Airport Moving Map Alert

Subject: Lusaka, Zambia
Kenneth Kaunda Intl (FLKK)
Cycle 2212

Aprons and Stands names incorrect

FLKK_2212

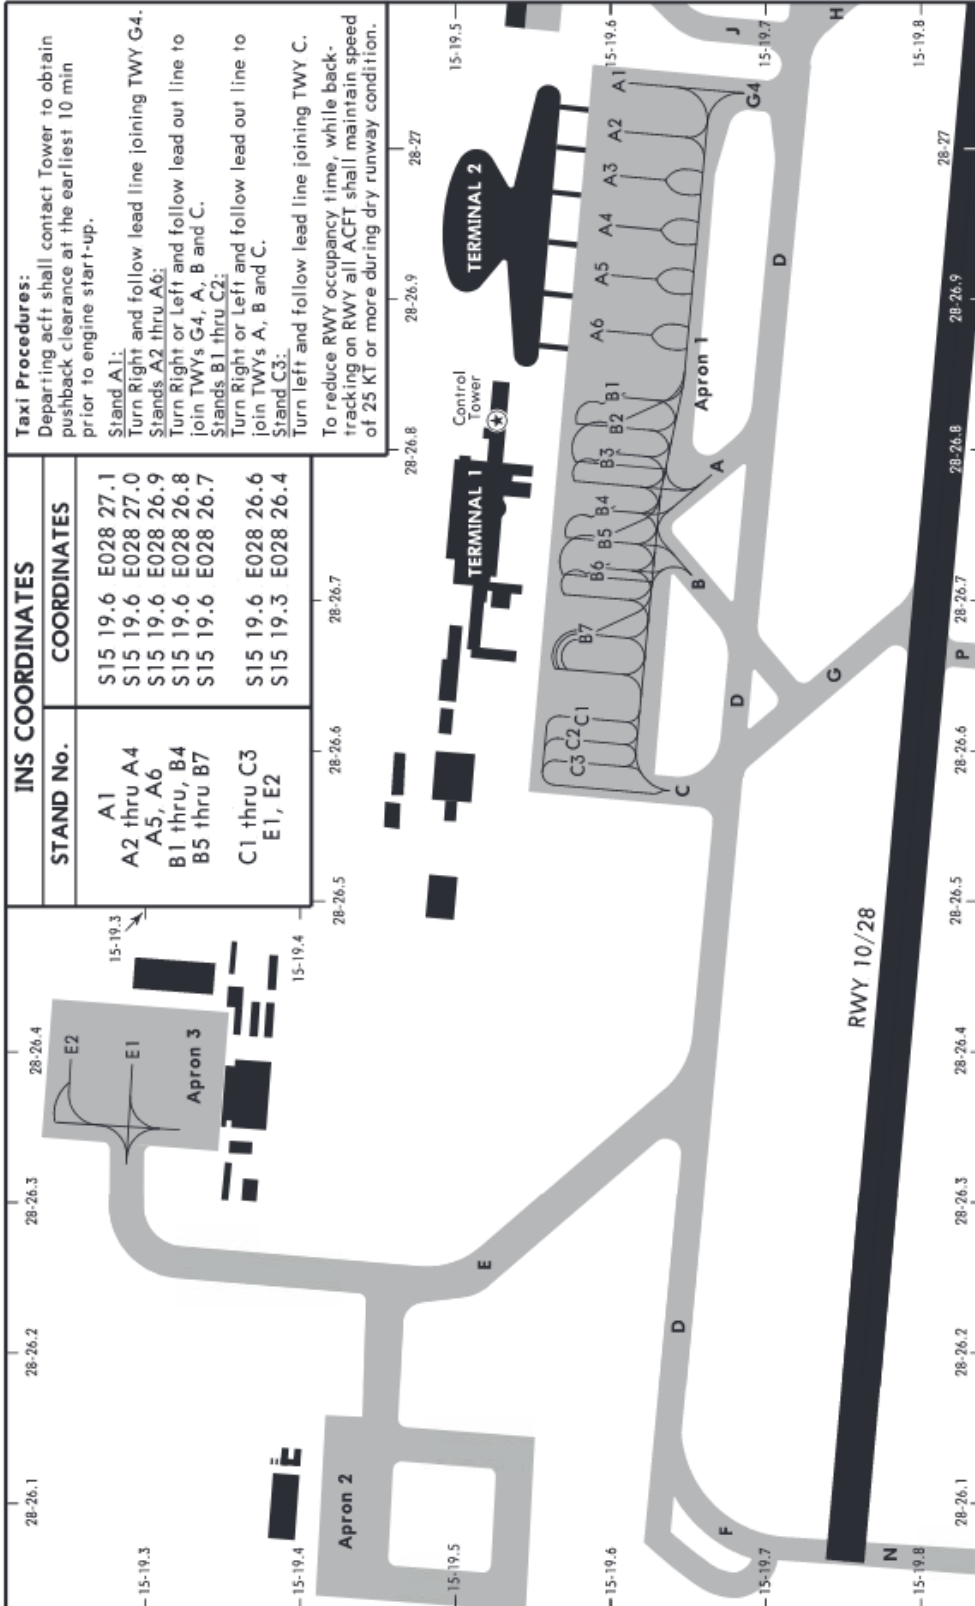
- Aprons A, B, C are renamed to Apron 1
- Apron D is renamed to Apron 2
- Apron E is renamed to Apron 3
- Stand B1x is renamed to Stand B2
- Stand B2 is renamed to Stand B3
- Stand B3 is renamed to Stand B4
- Stand B3x is renamed to Stand B5
- Stand B4 is renamed to Stand B6
- Stand B5 is renamed to Stand B7

CHANGES: Apron designations, stands B1X thru B5 renumbered B2 thru B7.

Revised data will appear in Jeppesen Airport Moving Map and A816 formatted data for cycle 2213, effective 29 December 2022. Until then this Alert will be posted on the Jeppesen Web site: [Notices and Alerts](#). Please refer to the local NOTAMs and Kenneth Kaunda Intl; Lusaka, Zambia 10-9A Chart, dated 09 DEC 22 for valid information.
